CAMP HIAWATHA ADDITION

TO WICHITA, SEDGWICK COUNTY, KANSAS

Re: S/D 95-66 CAMP HIAWATHA ADDITION (Final Plat)

STAFF REPORT

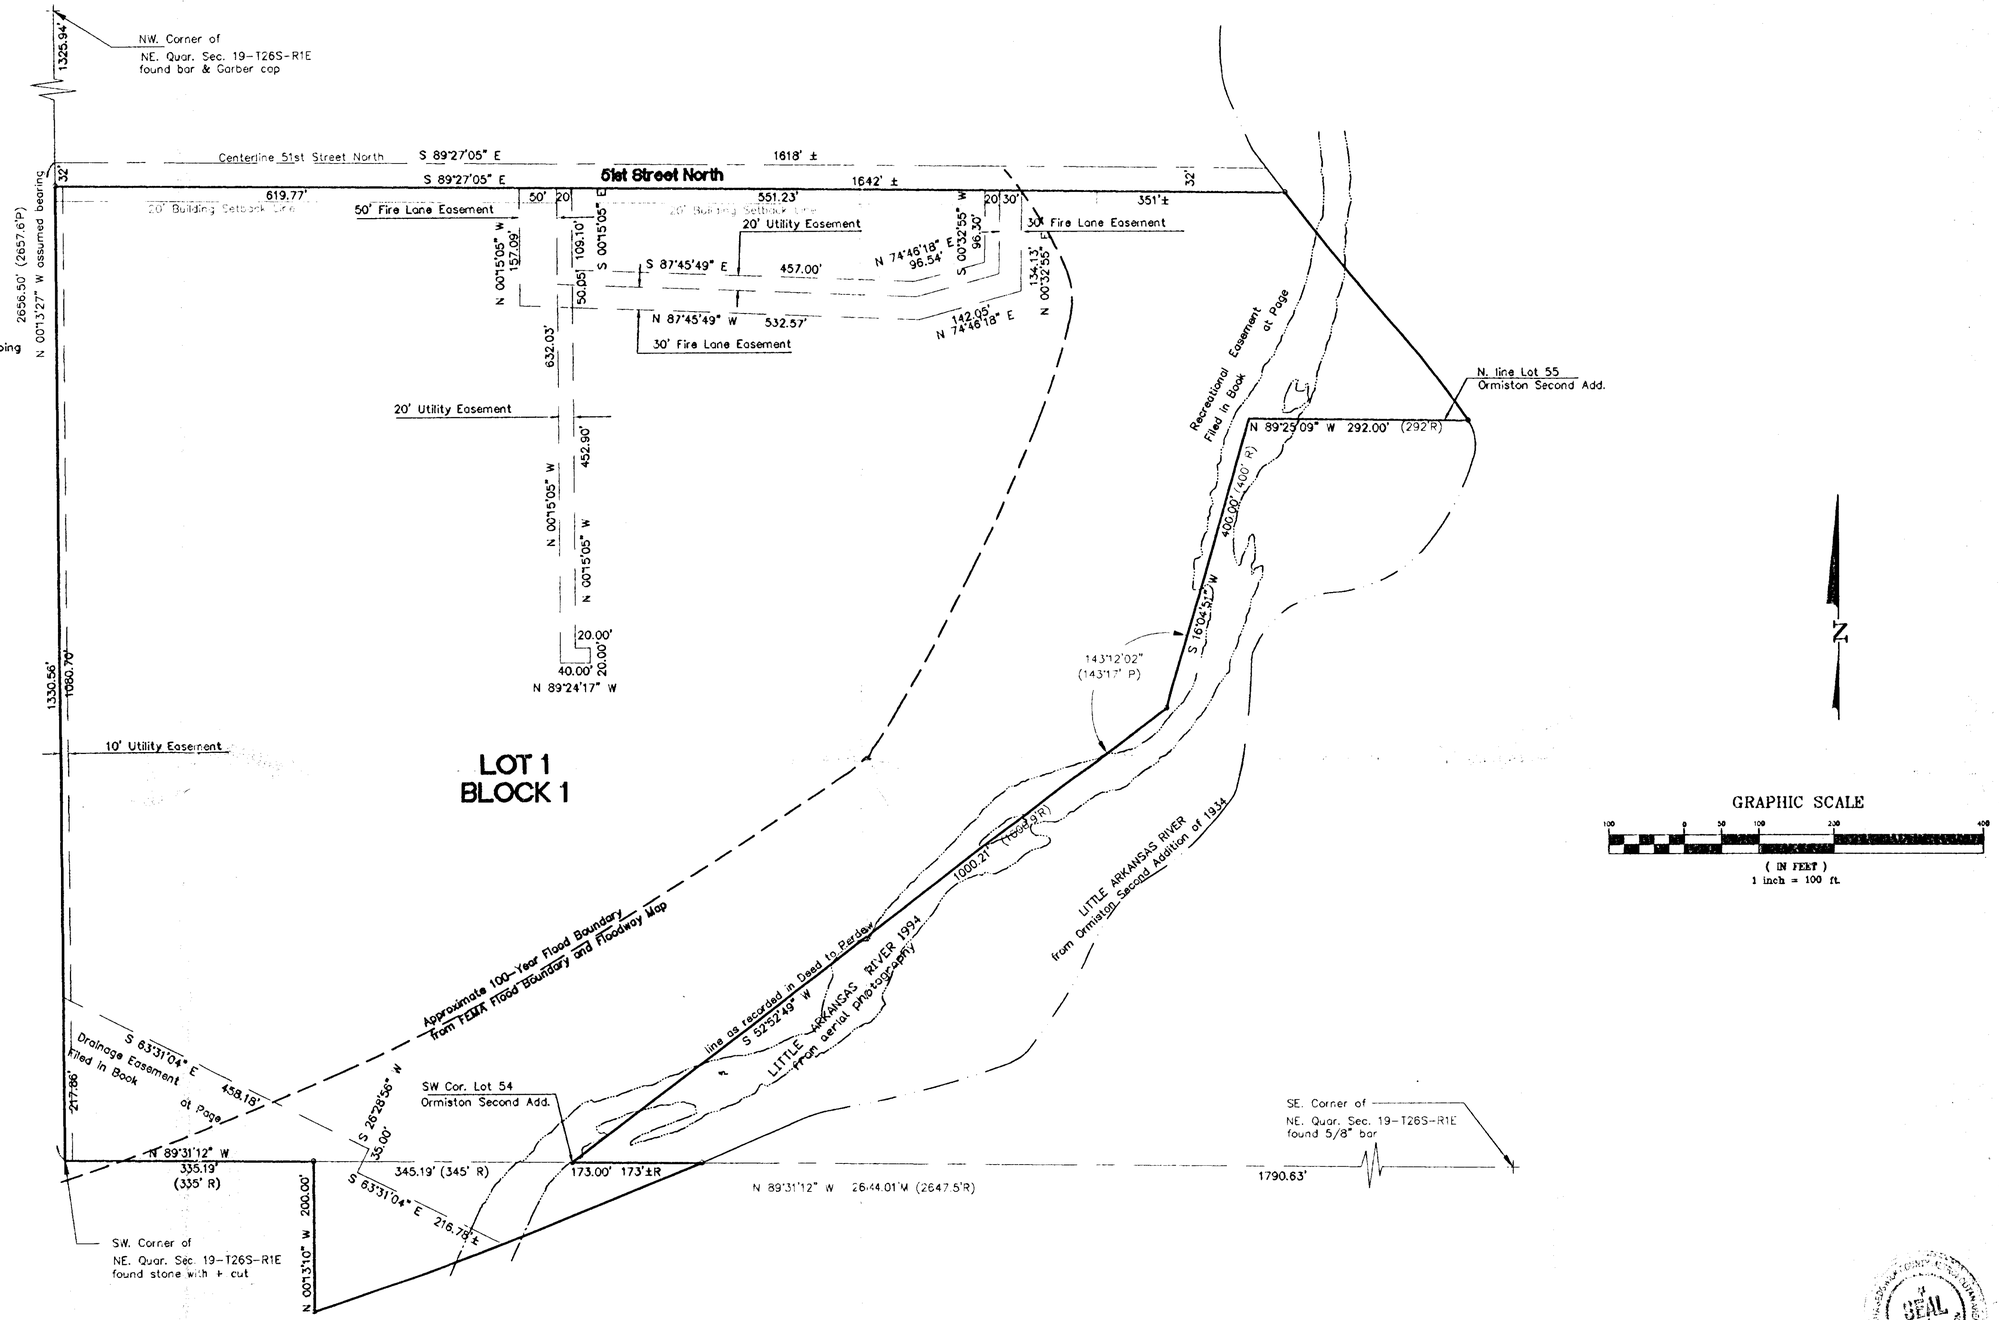
~~H.~~ Since this plat shows the platting of a floodway, the final plat tracing shall reference in the plattor's text the standard floodway language. — no FEMA floodway actually appears involved? Not needed D. 2 3 4/97

~~I.~~ In regard to the indicated floodway boundary, the depiction of an "approximate" boundary is acceptable.

~~J.~~ On the final plat tracing, the recording information for the drainage easement at the southwest corner of the site shall be provided.

~~K.~~ The perimeters of plats or at least lots are typically, if not always, shown by solid lines. This final plat, however, is using dashed lines at the northeast and southwest corners of the plat. The legend indicates that such symbols are also indicating the centerline of the river as of 1934 platting. The applicant's agent needs to clarify if the final plat tracing will also show dashed lines for these sections of the plat and the justification for doing so.

L. Since this plat is platting a floodway, minimum building pad elevations would typically also be required. City Engineering needs to indicate if minimum building pad elevations are required. If required, the elevation shall be noted both on the face of the plat and in the plattor's's text. 100 yr flood plain ⇒ min PD

~~P.~~ Perimeter closure computations shall be submitted with the final plat tracing. Section

R. On the final plat tracing, the City Clerk's signature line shall be amended to delete Deputy.

T. The final plat shall indicate the utility easements requested by K.G.& E. -Electric which are indicated on the enclosed "marked" copy of the plat.

K. The perimeters of plats or at least lots are typically, if not always, shown by solid lines. This final plat, however, is using dashed lines at the northeast and southwest corners of the plat. The legend indicates that such symbols are also indicating the centerline of the river as of 1934 platting. The applicant's agent needs to clarify if the final plat tracing will also show dashed lines for these sections of the plat and the justification for doing so.

L. Since this plat is platting a floodway, minimum building pad elevations would typically also be required. City Engineering needs to indicate if minimum building pad elevations are required. If required, the elevation shall be noted both on the face of the plat and in the plattor's's text.

R. On the final plat tracing, the City Clerk's signature line shall be amended to delete Deputy.

T. The final plat shall indicate the utility easements requested by K.G.& E. -Electric which are indicated on the enclosed "marked" copy of the plat.
